#### SCHEDULE OF CHANGES

Rev.	Date	By	Ckd	Description
G	17/08/2023	WN	DN	S4.56 Issue 2

30 Fairlight St, Fairlight  
30 Fairlight St,  
Fairlight, NSW 2094

DA201  
G

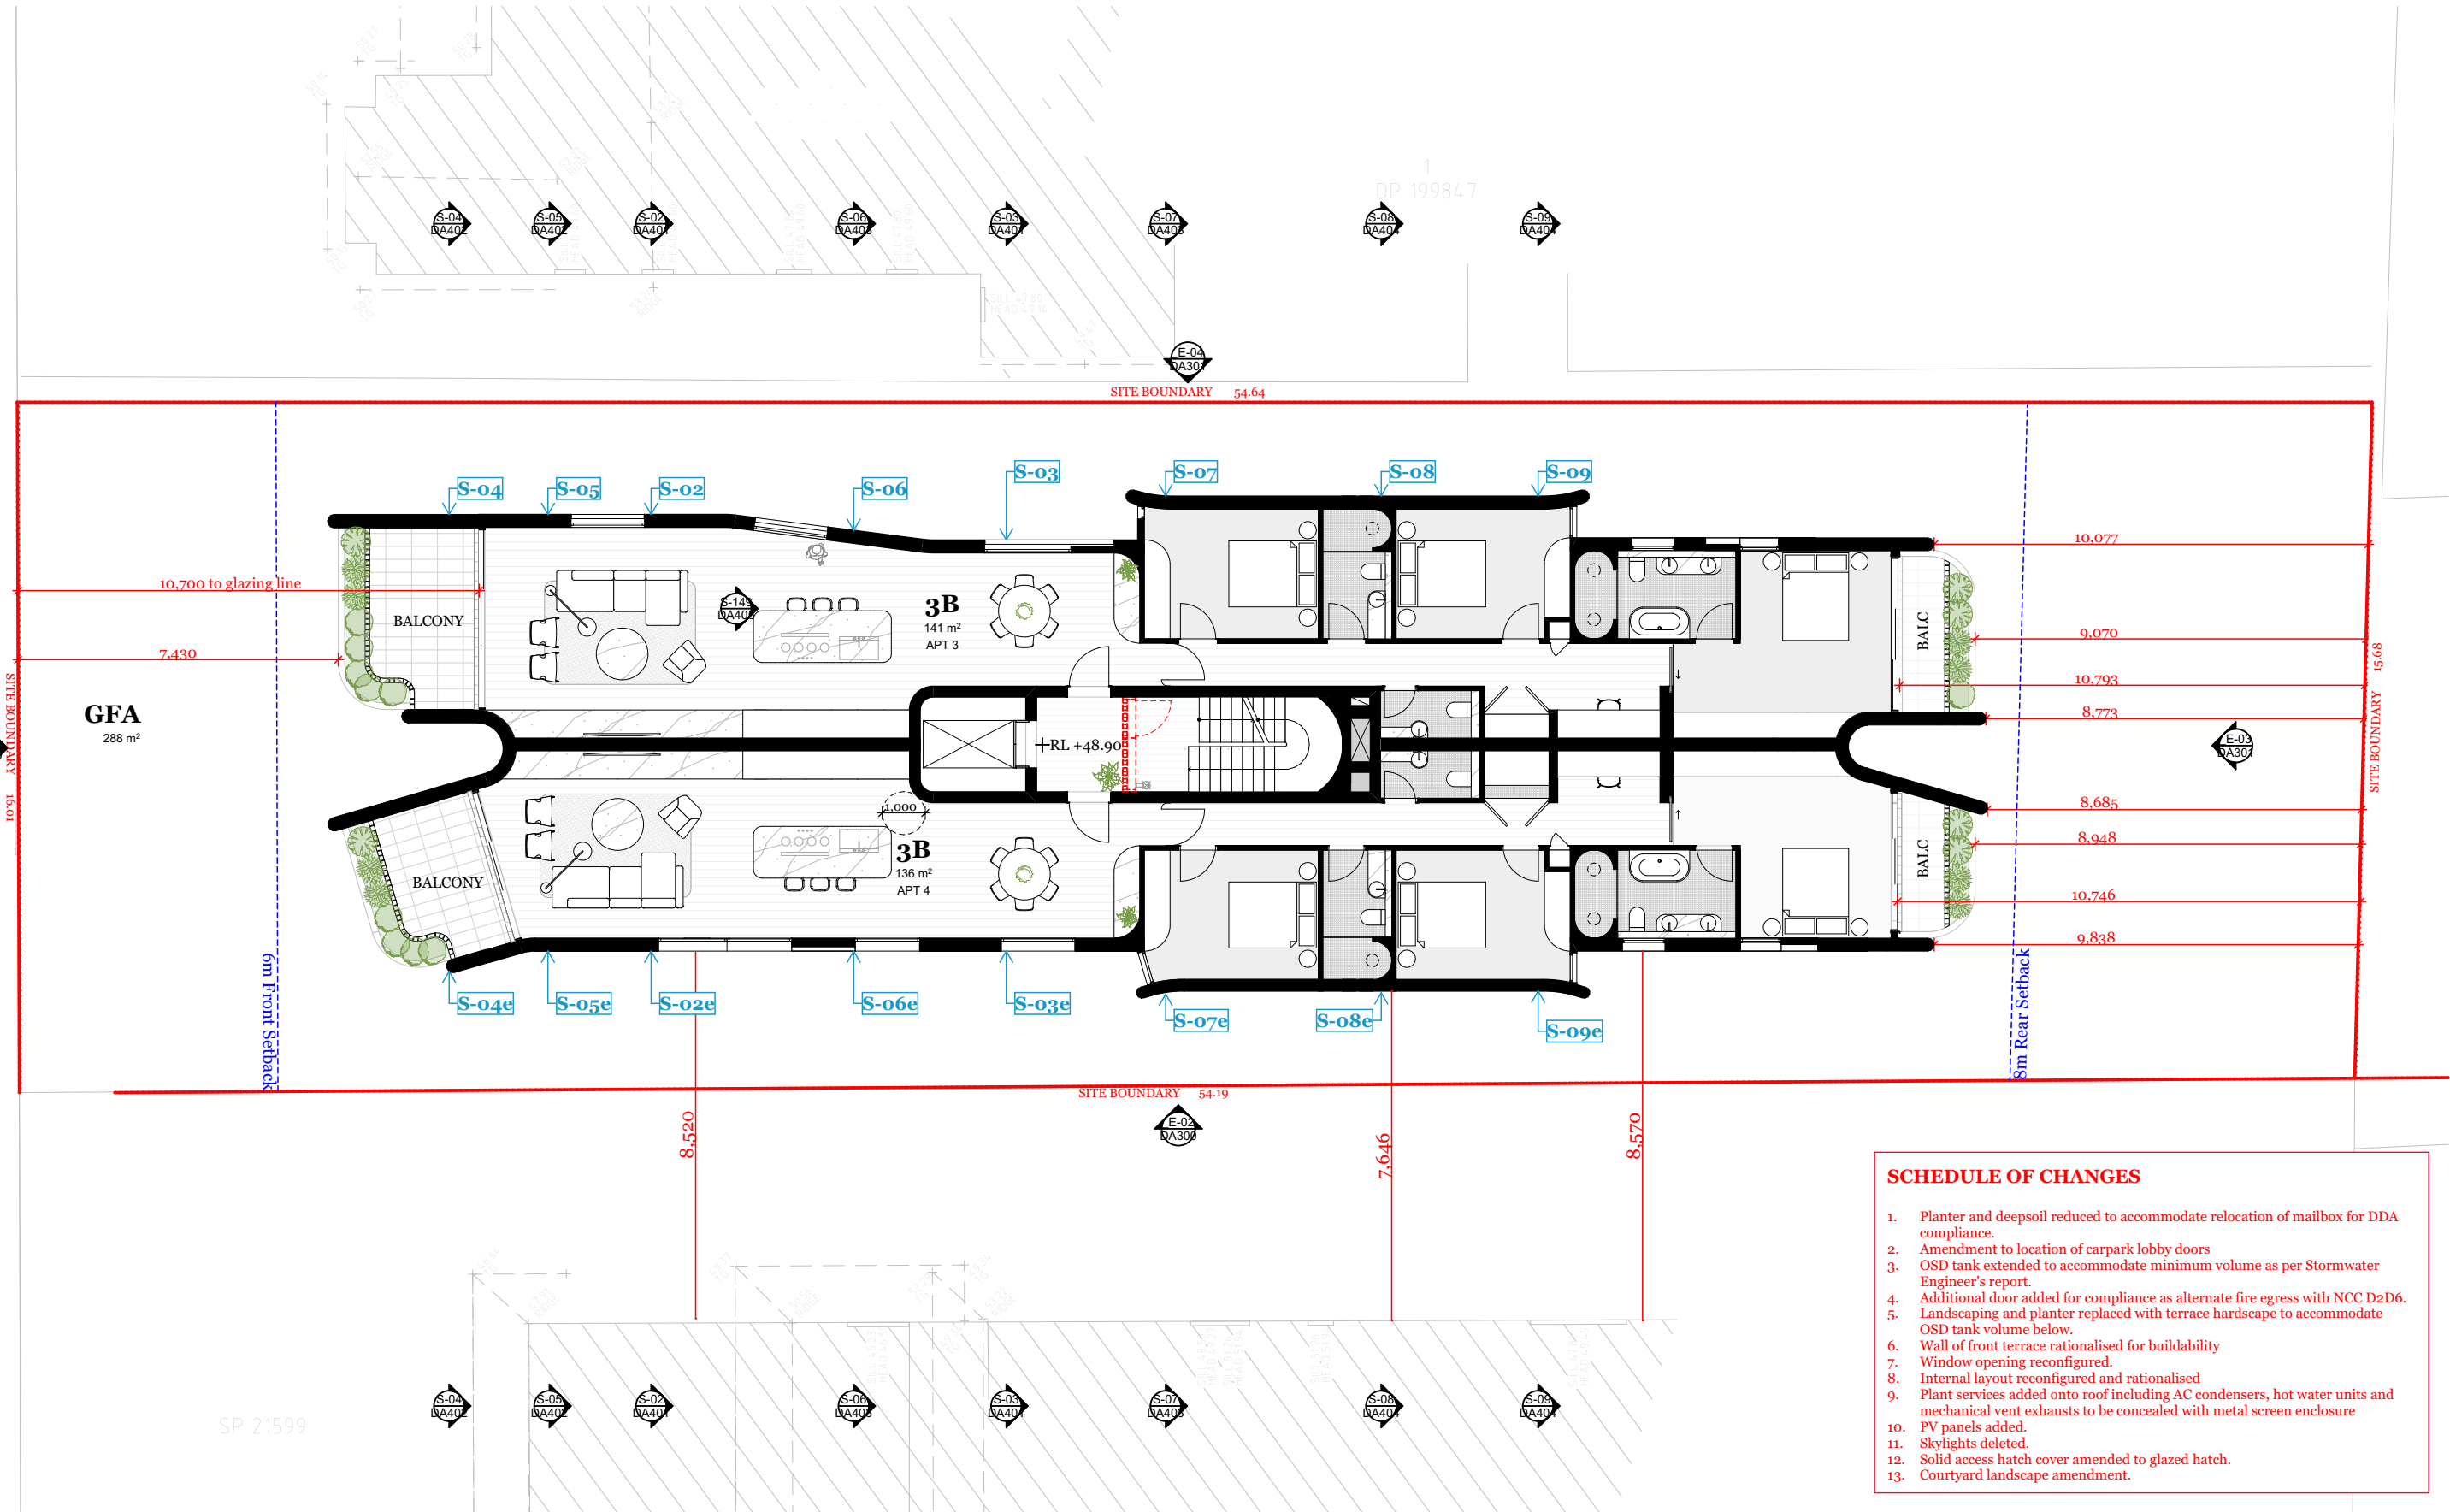
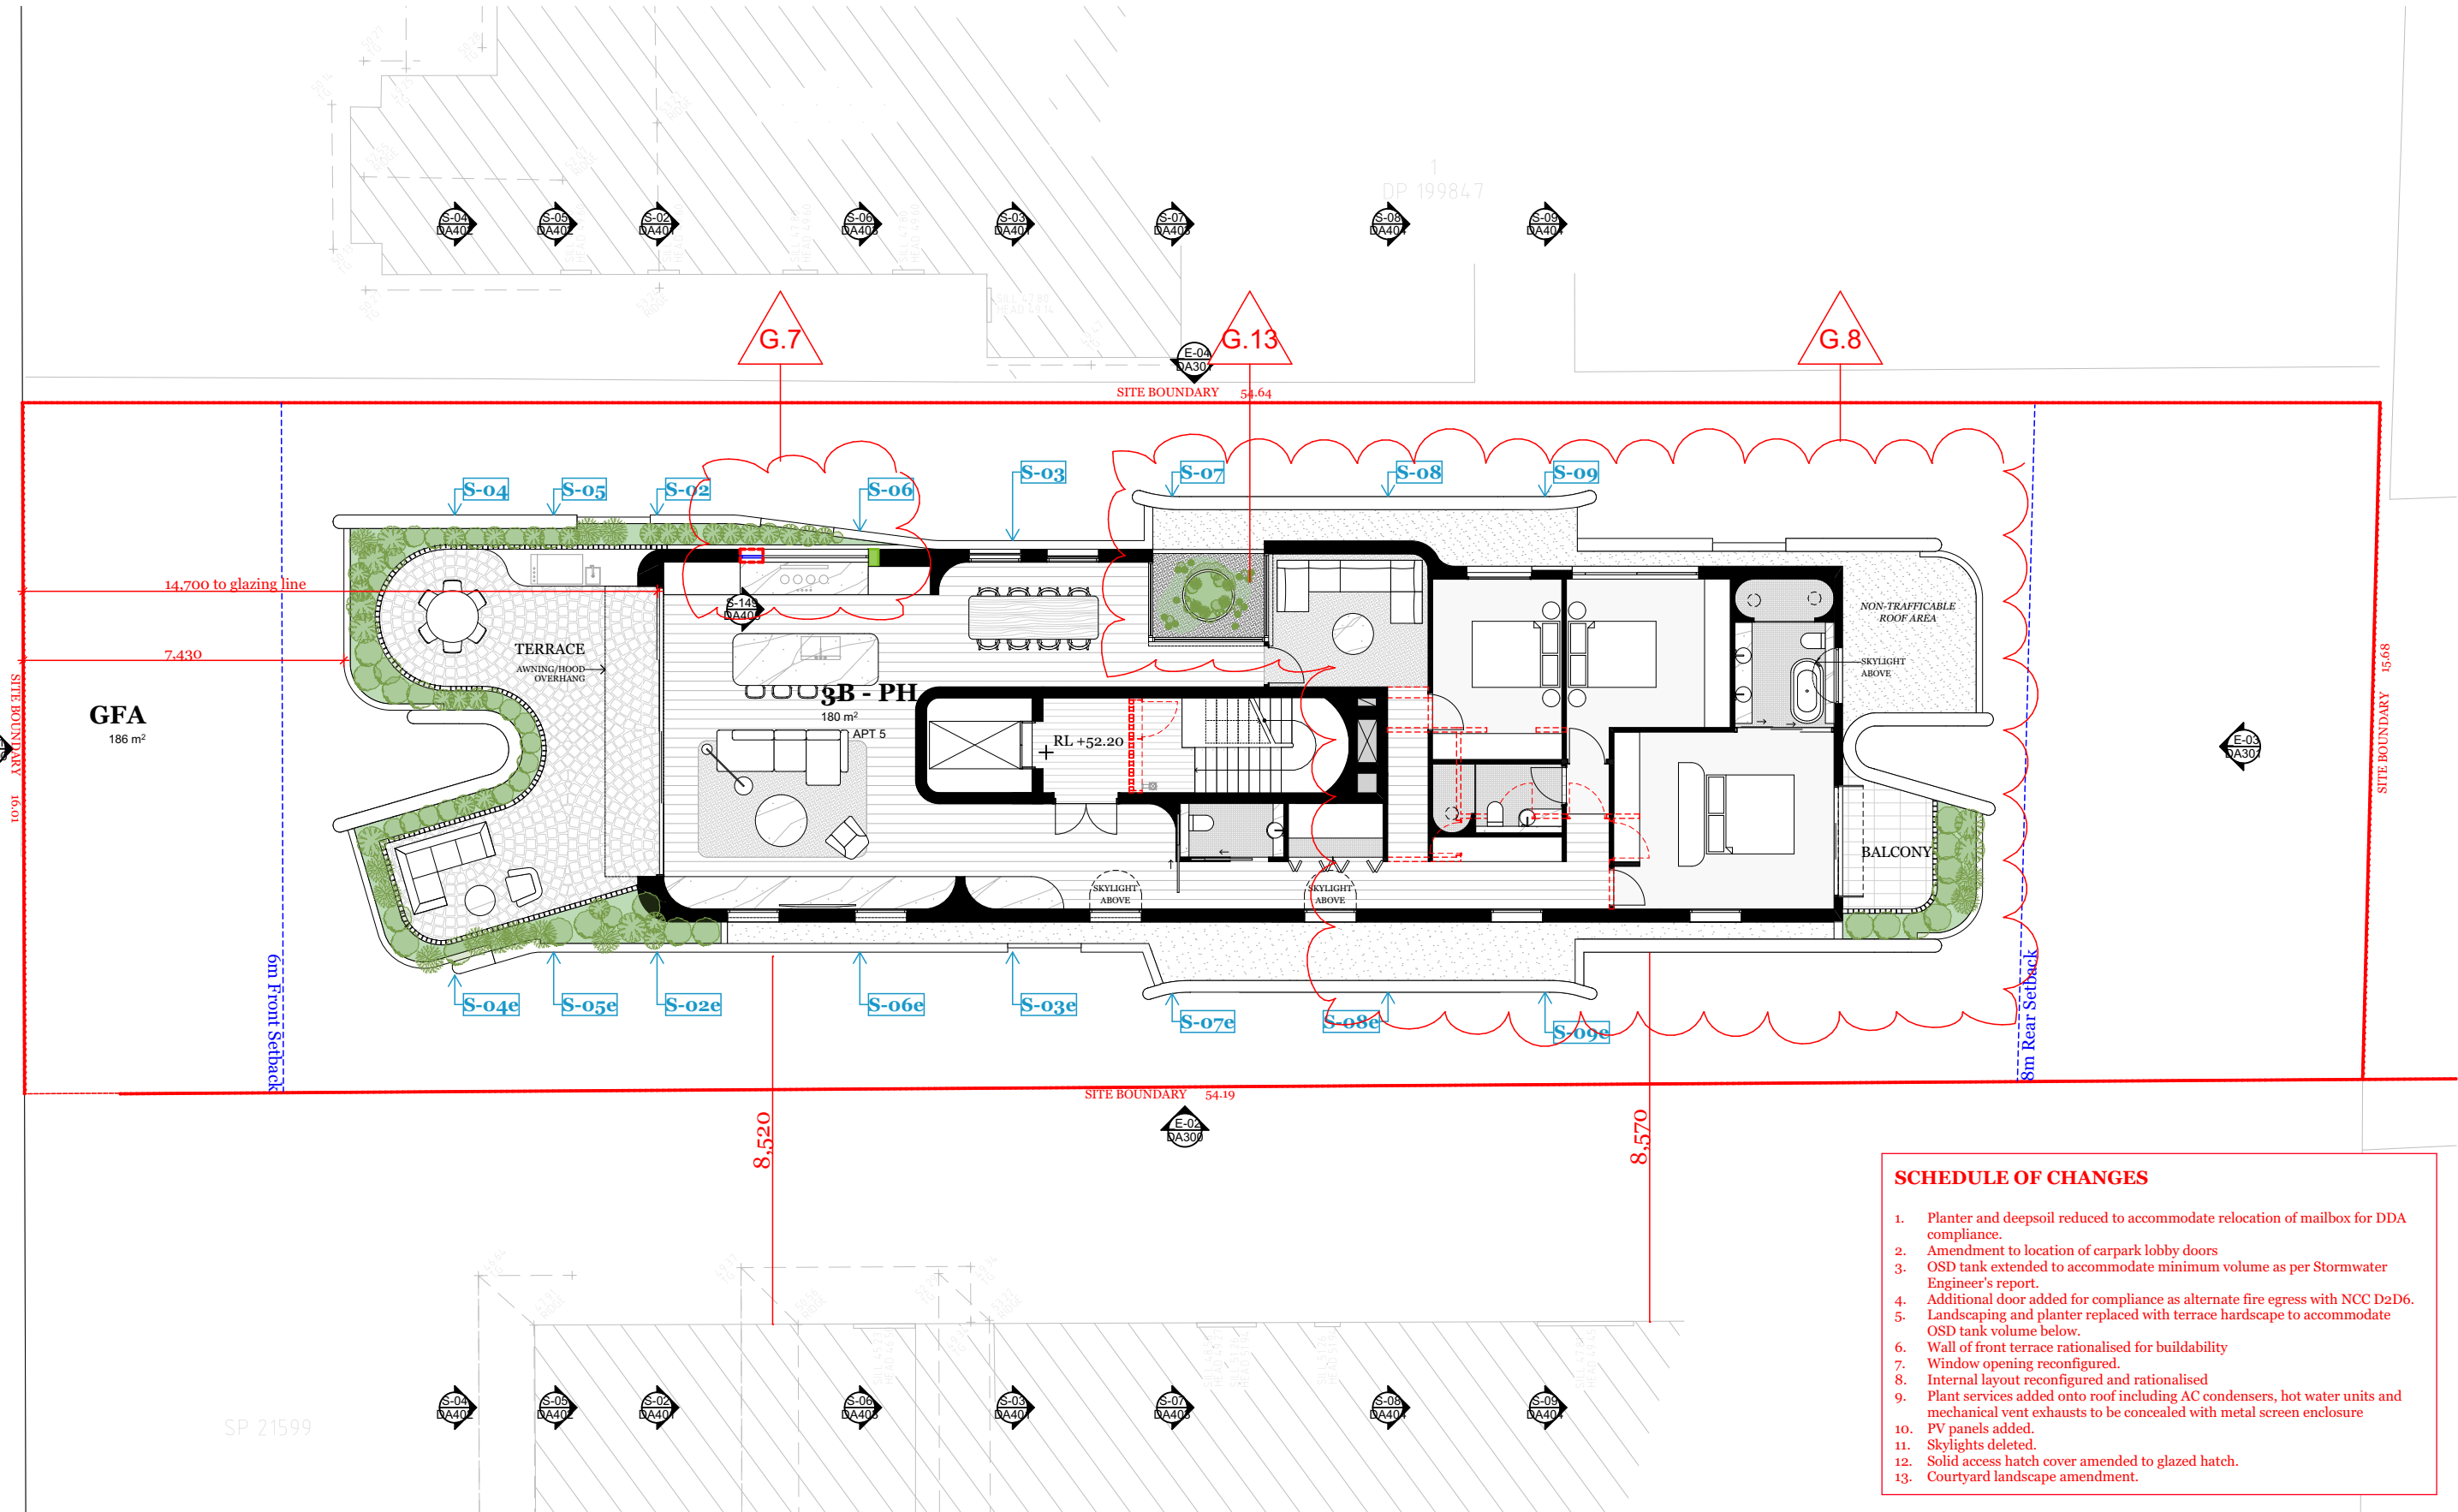
1. Planter and deepsoil reduced to accommodate relocation of mailbox for DDA compliance.
2. Amendment to location of carpark lobby doors
3. OSD tank extended to accommodate minimum volume as per Stormwater Engineer's report.
4. Additional door added for compliance as alternate fire egress with NCC D2D6.
5. Landscaping and planter replaced with terrace hardscape to accommodate OSD tank volume below.
6. Wall of front terrace rationalised for buildability
7. Window opening reconfigured.
8. Internal layout reconfigured and rationalised
9. Plant services added onto roof including AC condensers, hot water units and mechanical vent exhausts to be concealed with metal screen enclosure
10. PV panels added.
11. Skylights deleted.
12. Solid access hatch cover amended to glazed hatch.
13. Courtyard landscape amendment.
